Product/Process Change Notice (PCN)														
<input type="checkbox"/> Major Change <input checked="" type="checkbox"/> Minor Change														
PCN Number: PCN_FrqXTAL_20250214 Affected Series: WE-XTAL Affected Part Number: 830065253, 830066198, 830066431, 830108214001, 830107088501 PCN Date: 2024-11-14 (YYYY-MM-DD) Effective Date: 2025-02-14 (YYYY-MM-DD)	Change Category: <input type="checkbox"/> Equipment/Location <input checked="" type="checkbox"/> General Data <input type="checkbox"/> Material <input type="checkbox"/> Process <input type="checkbox"/> Product Design <input type="checkbox"/> Shipping/Packaging <input type="checkbox"/> Supplier <input type="checkbox"/> Software													
Contact: Product Management Phone: +49 (0) 7942 - 945 5001 Fax: +49 (0) 7942 - 945 5179 E-Mail: pcn.eisos@we-online.com	Datasheet Change: <input checked="" type="checkbox"/> Yes <input type="checkbox"/> No Attachment: <input type="checkbox"/> Yes <input checked="" type="checkbox"/> No

5. Update of Reflow information:

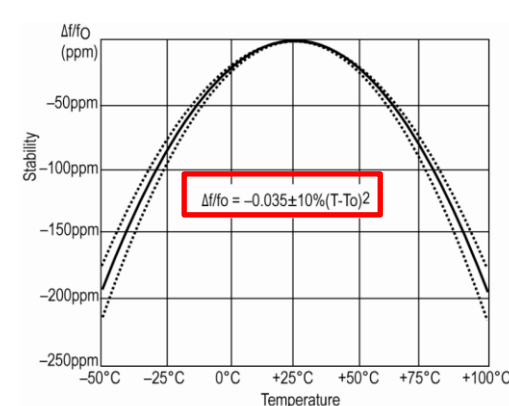
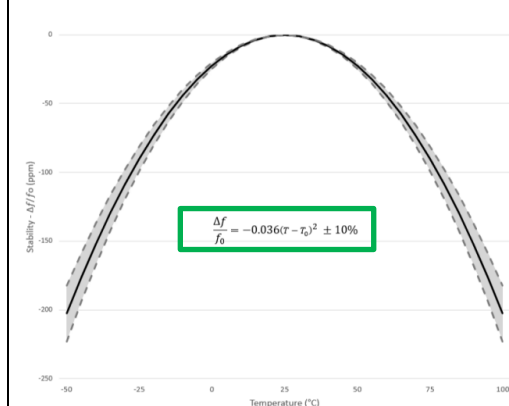
Before	After
Reflow information	Maximum Process Temperature: 260 °C for 10 secs max	<p>Reflow Profile</p> <p>Note: (1) The temperature used herein means the temperature on the circuit board. (2) Reflow is permitted 2 times.</p>

6. Correction of the RoHS Status:

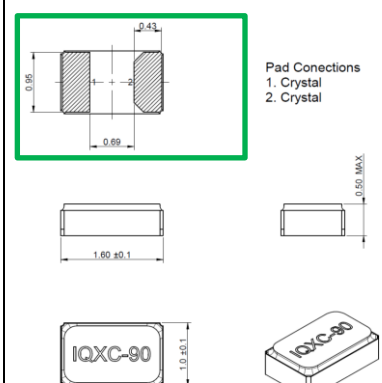
Before	After
RoHS Status	Compliant (2011/65/EU)	Compliant (2015/863/EU)
